**CITY PLAN COMMISSION****THURSDAY, SEPTEMBER 4, 2025****RECORD NO.:** PLAT-25-000070 (S245-220) **SENIOR PLANNER:** Sharmila Shrestha**LOCATION:** Baraboo Drive, southeast of Mehalia Drive**DATE FILED:** August 6, 2025**ZONING:** MF-2(A)**CITY COUNCIL DISTRICT:** 8**SIZE OF REQUEST:** 19.925-acres**APPLICANT/OWNER:** Lincoln Avenue Communities, MT Tabor Baptist Church

**REQUEST:** An application to create one 19.925-acre lot from a tract of land in City Block 6869 and 6870 on property located on Baraboo Drive, at the terminus of Happy Canyon Drive.

PRELIMINARY PLAT OF  
**TABOR VILLAGE**  
**LOT 1, BLOCKS 6869 AND 6870**

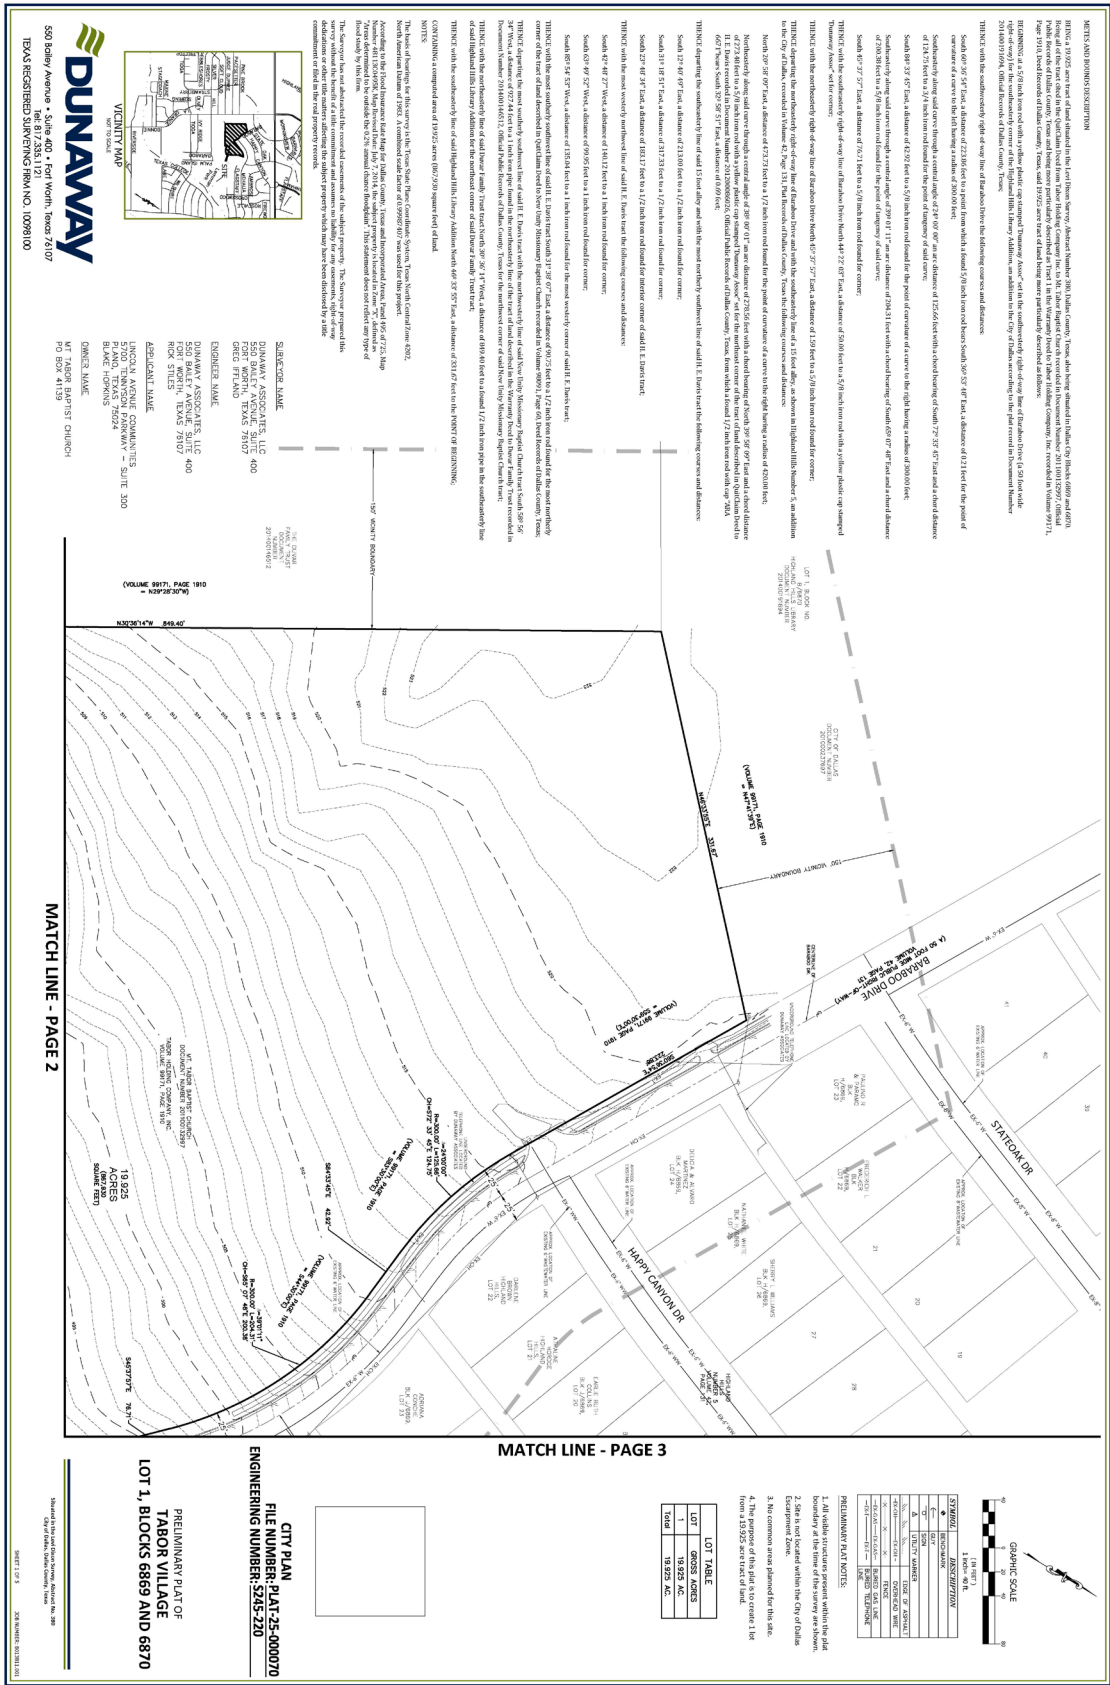
**Dallas Water Utilities Conditions:**

23. Additional design information is required for assessment. Site plan must be submitted showing proposed development, building finished floor elevation, development, existing mains – including downstream manhole, and proposed water and wastewater service locations. Submit water/wastewater engineering plans to 320 E. Jefferson Blvd., Room 200, Attention: Water and Wastewater Engineering.
24. Water and wastewater main improvements are required by Private Development Contract. Submit water/wastewater Engineering Plans to 320 E. Jefferson Blvd., Room 200, Attention: Water and Wastewater Engineering.
25. Existing and any proposed Water and Wastewater Easements must be shown and/or increased to conform to current design standards. **Notice:** Minimum DWU easement size 20' for one utility and 25' for both water and sewer. Larger diameter or deeper mains may require additional width.
